# Application for approval to amend the Implementation Plan Regarding the Handling of ALPS Treated Water [Overview]

November 14, 2022  
Tokyo Electric Power Company Holdings, Inc.

- Today, on November 14<sup>th</sup>, we submitted the "Application Documents for Approval to Amend the Implementation Plan for Fukushima Daiichi Nuclear Power Station Specified Nuclear Facility" to the NRA, with additional details/revisions on the organizational structure for operating, maintaining, and managing the ALPS treated water dilution/discharge facilities, nuclides to be measured/assessed to confirm that the ALPS treated water meets the discharge criteria before it is discharged into the sea, and the radiological environmental impact assessment results given the changes to the nuclides to be measured/assessed.

# 3-4. Selection of nuclides to be measured and assessed through inventory assessment

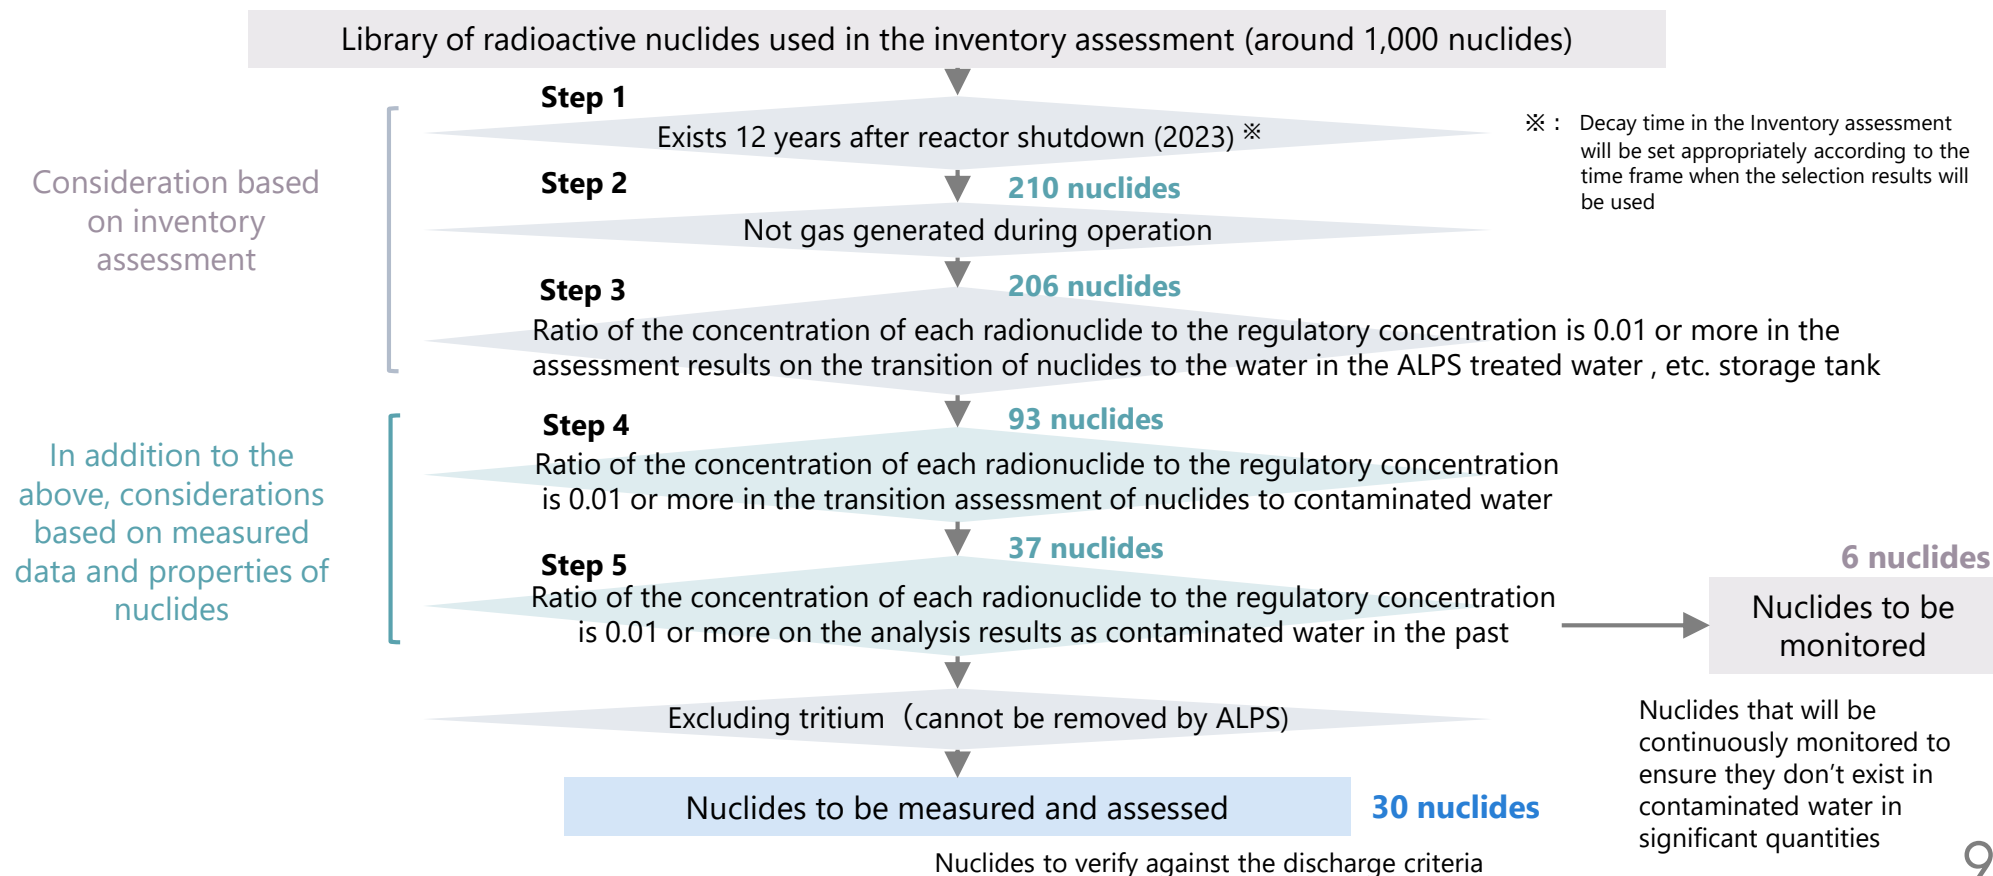
- The nuclides to be measured and assessed were selected using the following process.
- Regarding the following process, first, the nuclides that can realistically exist are selected considering the half-life of the nuclides based on the findings pointed by the IAEA and the NRA. Next, we conduct another desk study assuming<sup>※</sup> that all of the radioactive materials have been transferred to the ALPS treated water storage tanks. Furthermore, the assessment is based on the actual measured data of contaminated water and the properties of nuclides that we have accumulated over the past 12 years.

- 30 nuclides in the table below and tritium are the nuclides to be measured and assessed in discharging the ALPS treated water into the sea, selected using the selection flow on the previous slide.
- These changes to the nuclides to be measured and assessed (4 nuclides were added and 37 removed from selection) will be reviewed by the NRA and the IAEA.
